FORM P2A: FINAL SIGN-OFF FOR MASTER DEVELOPMENT PLANS AND SITE PLANS - EPC

FINAL SIGN-OFF FOR MASTER DEVELOPMENT PLANS AND SITE PLANS – EPC

OFFICIAL NOTIFICATION OF DECISION

Project #2020-004457
SI-2021- 00651 - Site Plan-EPC
VA-2021-00145 - Variance-EPC

ENGINEER'S SEAL DAVID SOULE P.E. #14522	QUIVIRA ESTATES SITE PLAN FOR BUILDING PERMIT	DRAWN BY: WCW/J DATE: 8-21-21 2102059-LAYOUT-8-06-20
	 Rio Grande Engineering 1606 CENTRAL AVENUE SE SUITE 201 ALBUQUERQUE, NM 87106 (505) 872-0999	SHEET # 1 JOB # 2102059

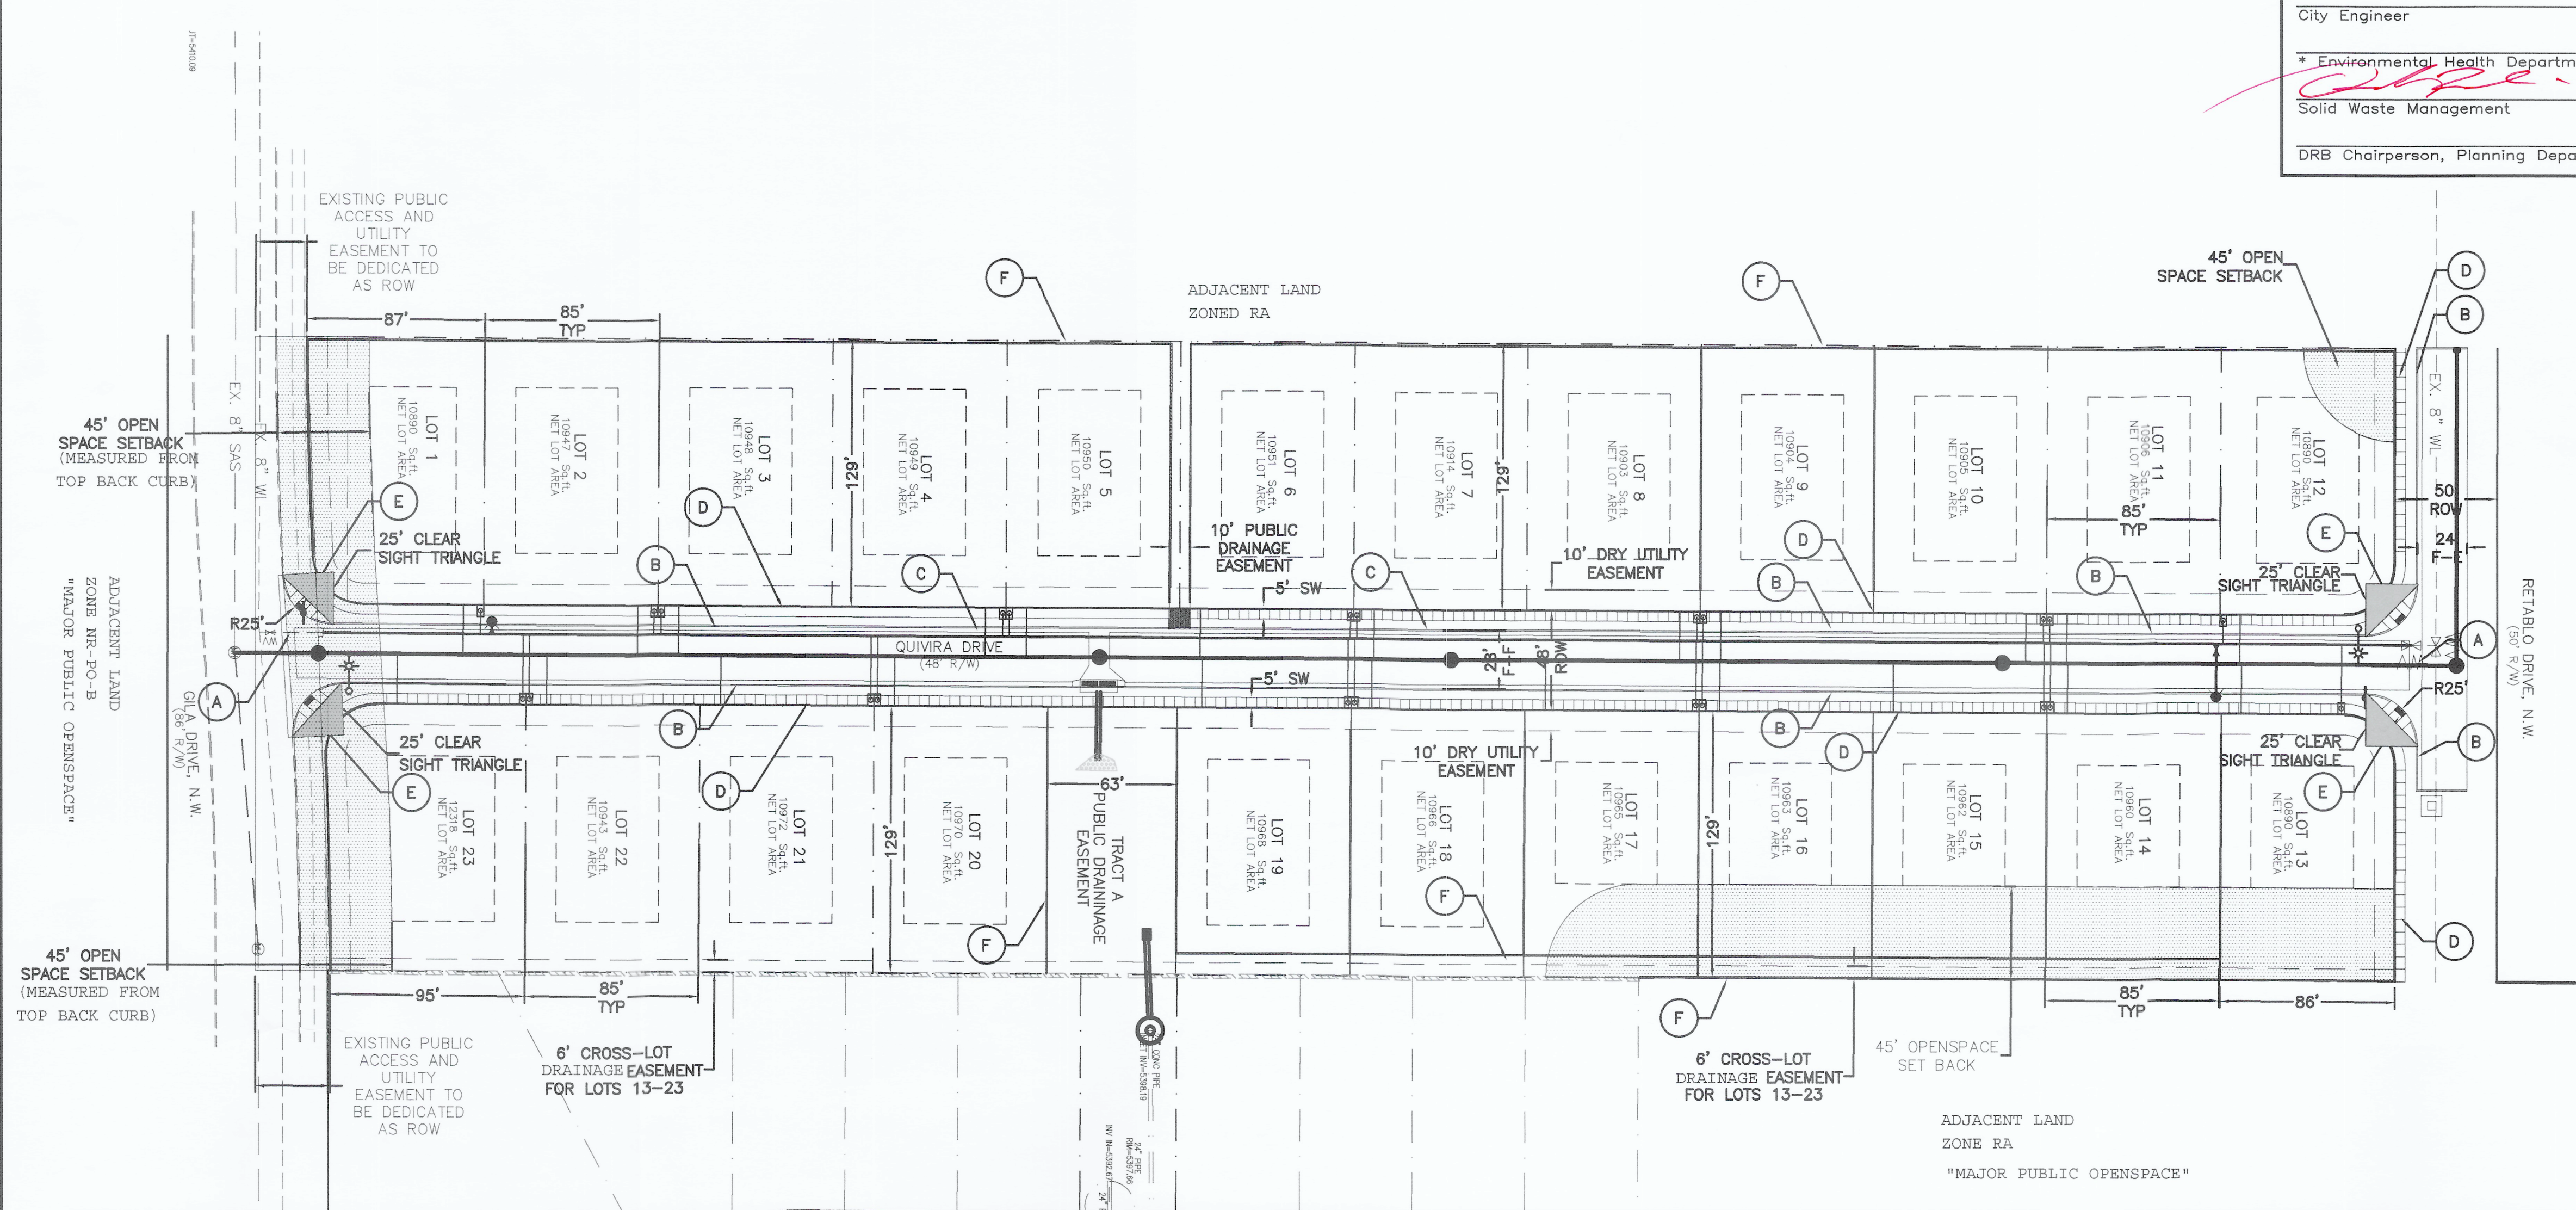
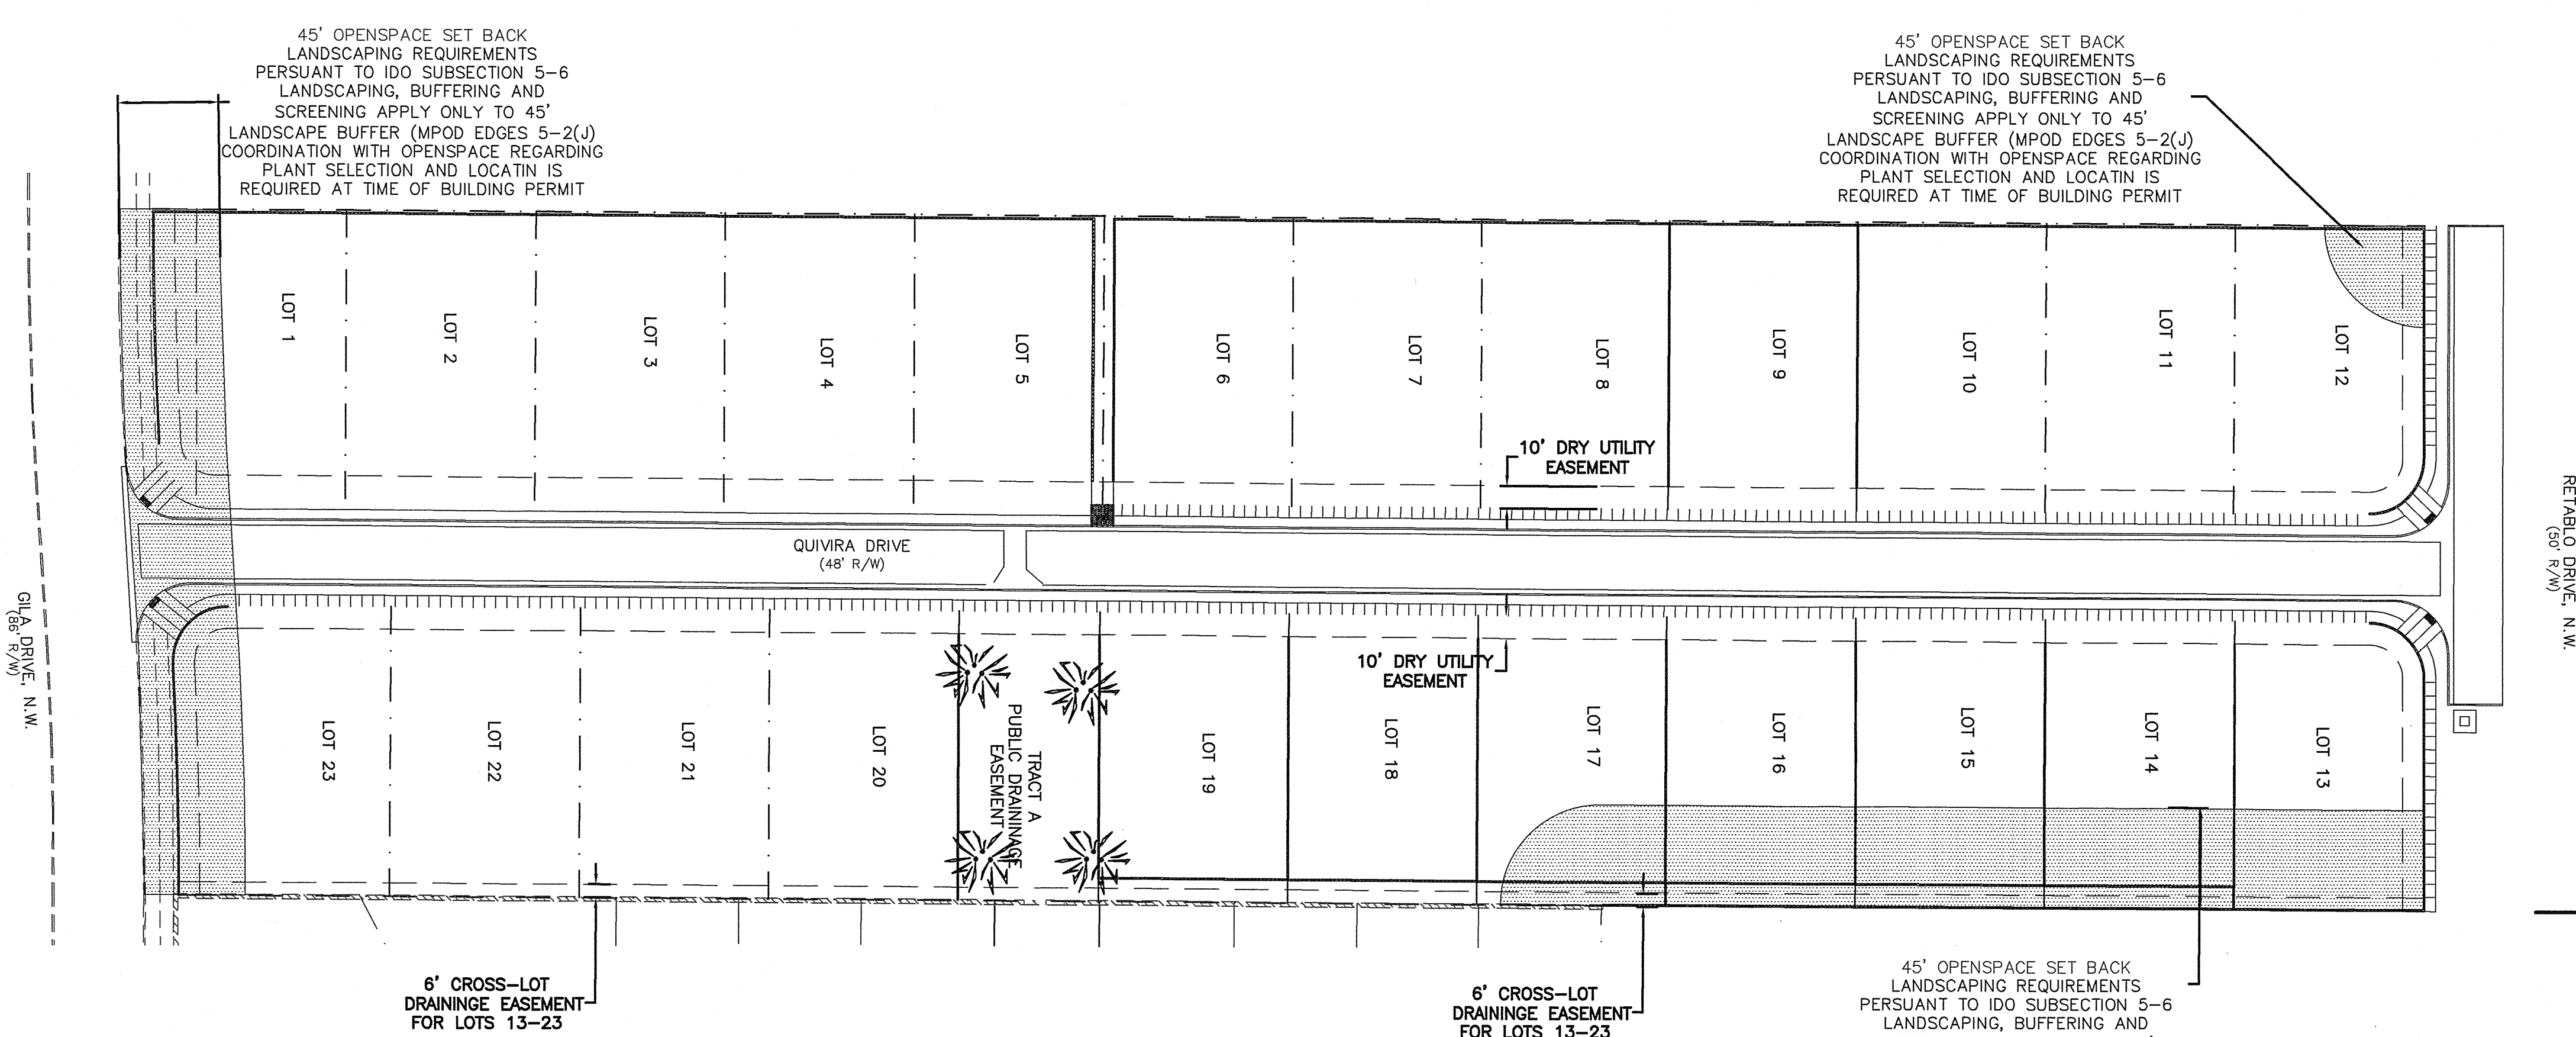
4. Dimensional Standards:
 - A. Lot 22 is shown at 10,378 square feet. The minimum lot size in R-A is 10,890 square feet. The site plan shall be revised to comply with Table 5-1-1 Dimensional Standards. **we have corrected this typo**

- B. The dimension across lot 16 is not placed properly, the site plan shall be revised to show accurate lot length. **revised**
 - C. Add “typical” to the lot width dimensions, if not all lots are 85’ in width, dimension at least one lot per typical width. **added (typ) and actual dimensions on not typical lots**

- D. Dimension both Major Public Open Space buffers to demonstrate that they are 45-feet in length. The buffer at the northwest corner of the lot appears to have a radius of only 40-feet, the site plan shall be dimensioned and/or revised for compliance. **revised**

- E. Provide typical dimensions for building setbacks pursuant to IDO subsection 14-16-3-4(N)3 Setback Standards. **see note 1 of epc conditions on sheet1**

A. The site plan shall be revised to fix spelling errors throughout document. **we have corrected spelling**

B. The site plan shall revise general note 13 to change “Volcano Cliffs” to “Volcano Mesa”. **corrected**

C. The site plan shall be revised to add general note 14: A single loaded street exists at southern boundary of lot adjacent to Major Public Open Space, therefore 45-foot buffer is not required. **I believe the city position changed on this,**

D. Keyed note F: One of the keyed notes does not have a leader attached, the site plan shall be revised to show what the keyed note was intended to call out. **corrected**

E. The site plan shall be revised to identify existing Major Public Open Space Boundaries abutting the subject site. **identified**

F. The site plan shall be revised to use a current vicinity map.

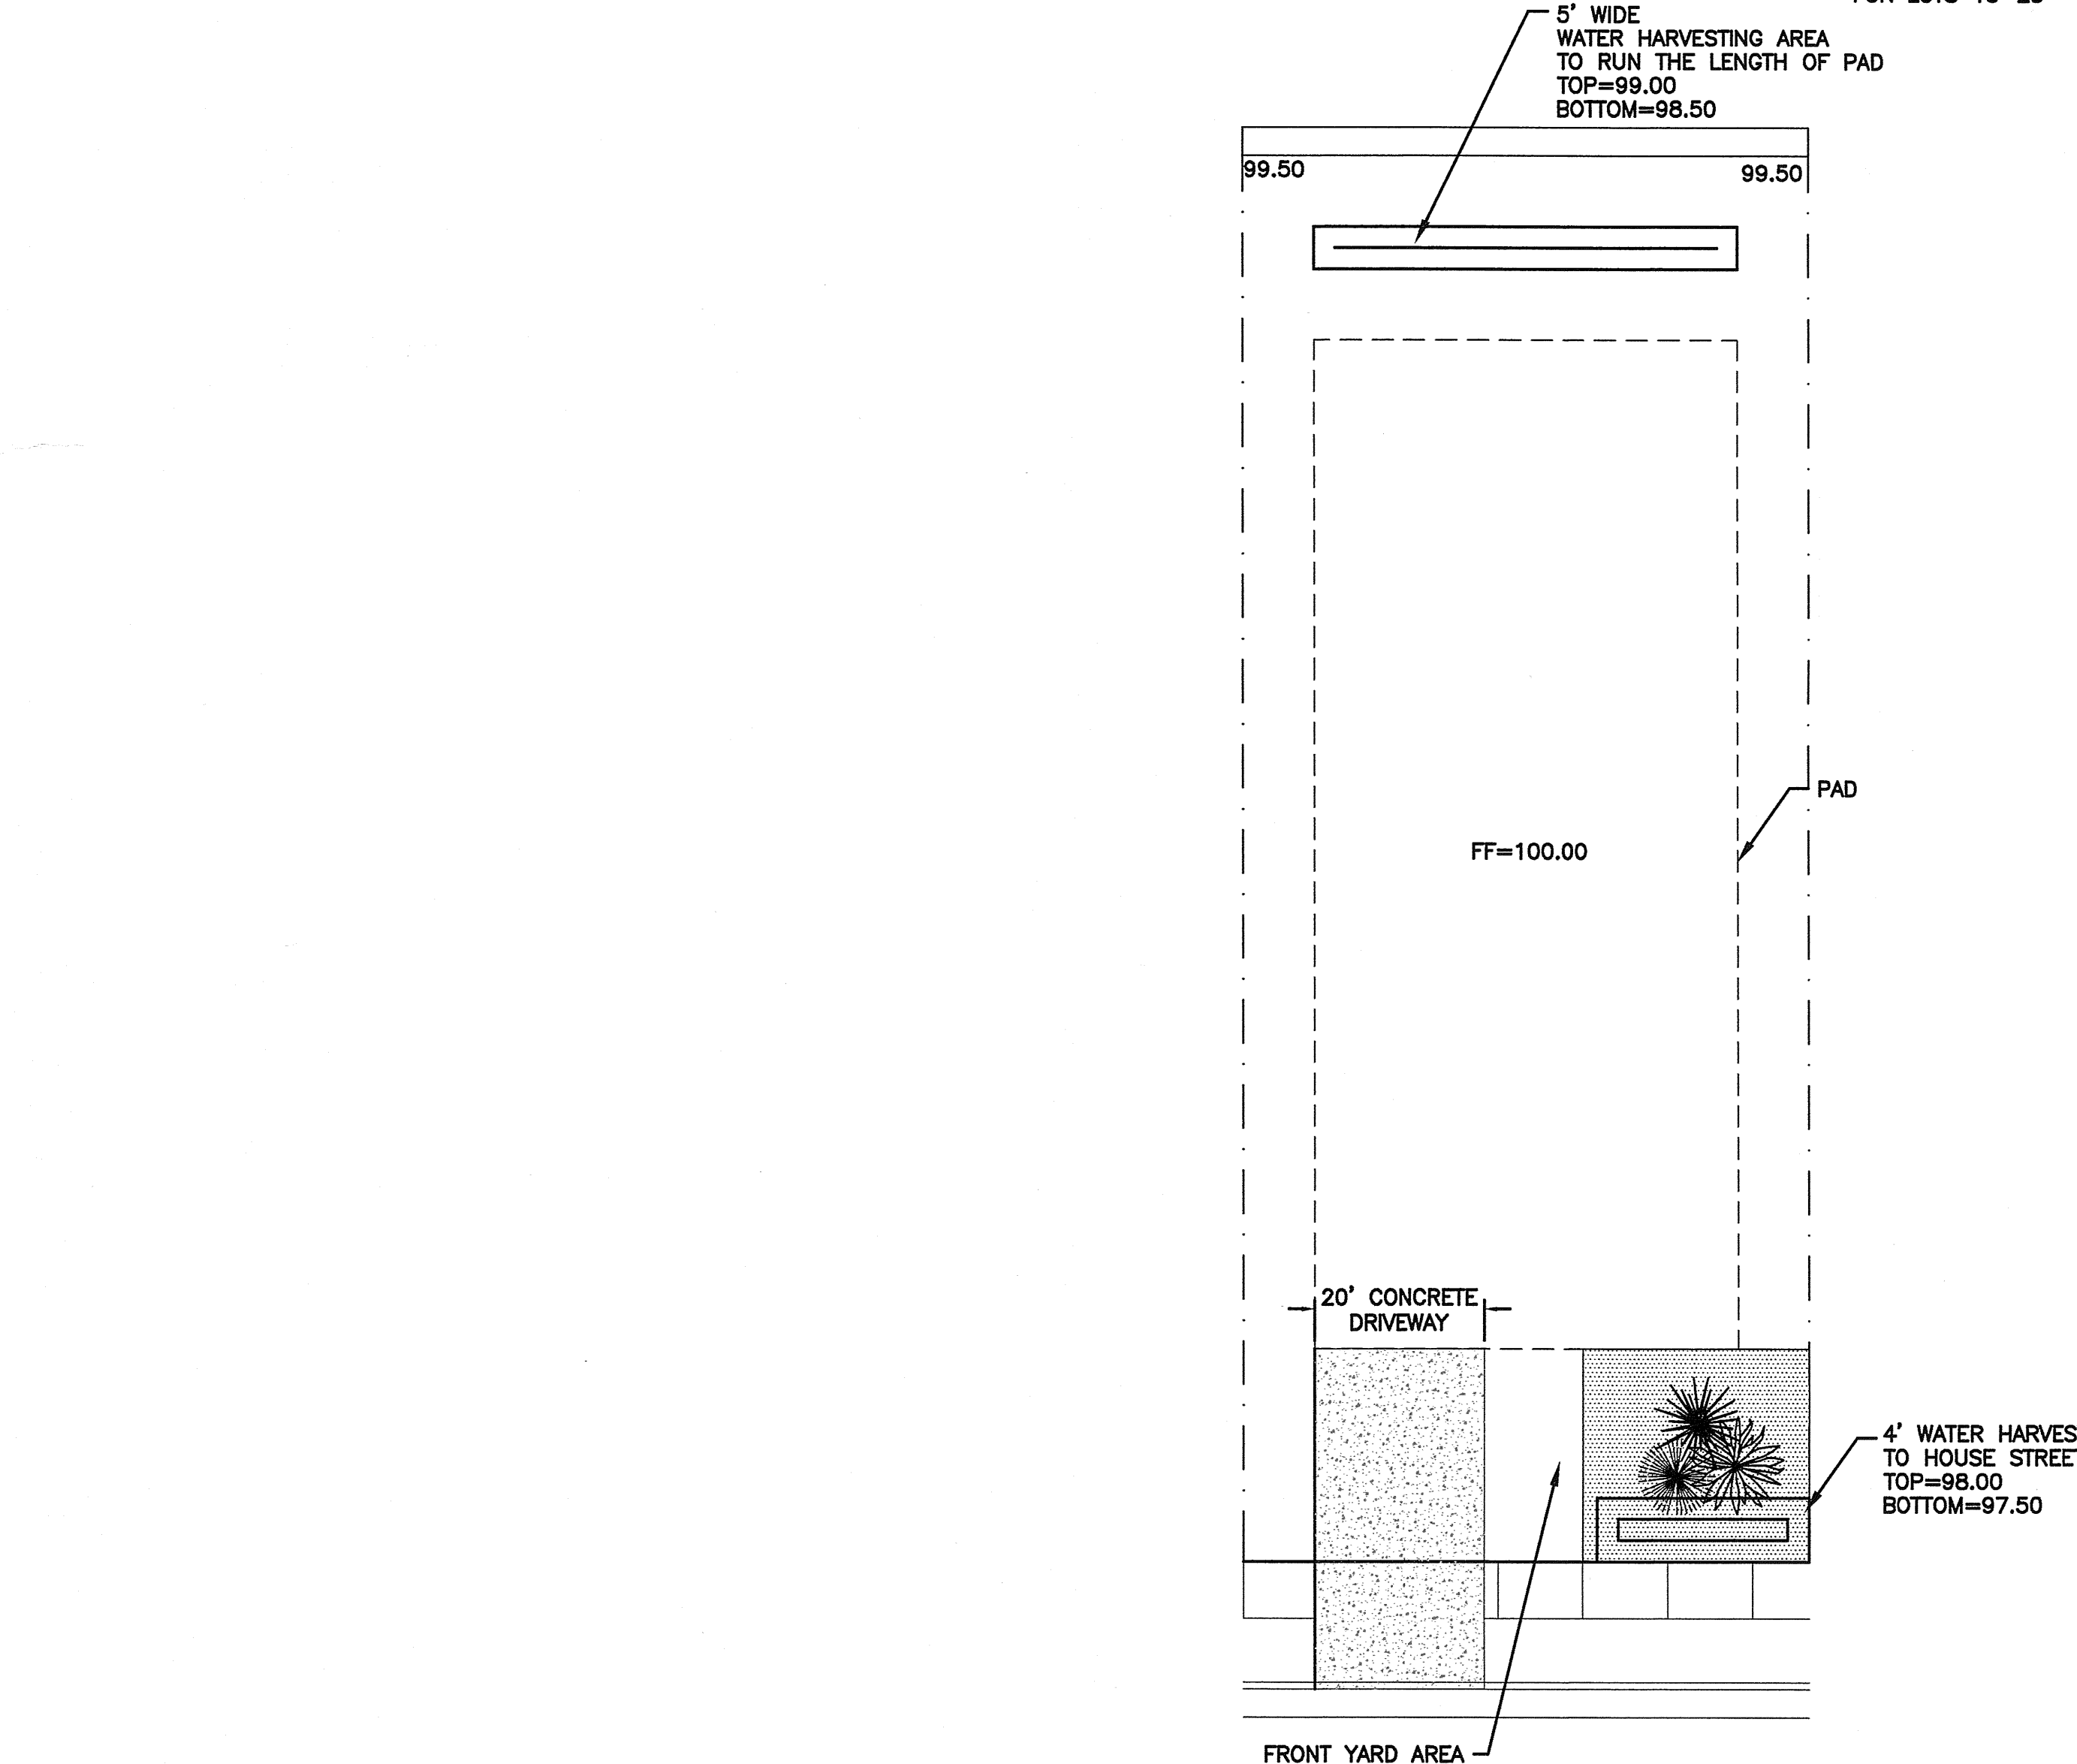
5. Landscaping - General:
 - A. A note shall be added to state: landscaping requirements pursuant to IDO subsection 5-6 Landscaping, Buffering, and Screening only apply to the 45-foot landscape buffer (required by MPOS Edges 5-2(J)). **added note**

B. The landscaping plan shall remove all notes referring to the 15% minimum landscape requirement, as it is not required in single-family residential development. **removed**

C. The note “Landscape plan shall adhere to IDO subsection 5-6(C)(4) through IDO subsection 5-6(C) (10)” shall be removed. **removed**

A. A 45-foot landscape buffer shall be added to the southern portion of the subject site as required by Open Space of the Parks and Recreation division, to begin at the location determined by Transportation Development Staff at DRB. **proposed back of curb**

B. The 45-foot landscape buffer shall be shown on the landscape plan, to include proposed landscaping. **added note and highlighted**

C. A note shall be added to indicate that coordination with Open Space regarding plant selection and location is required. **added**
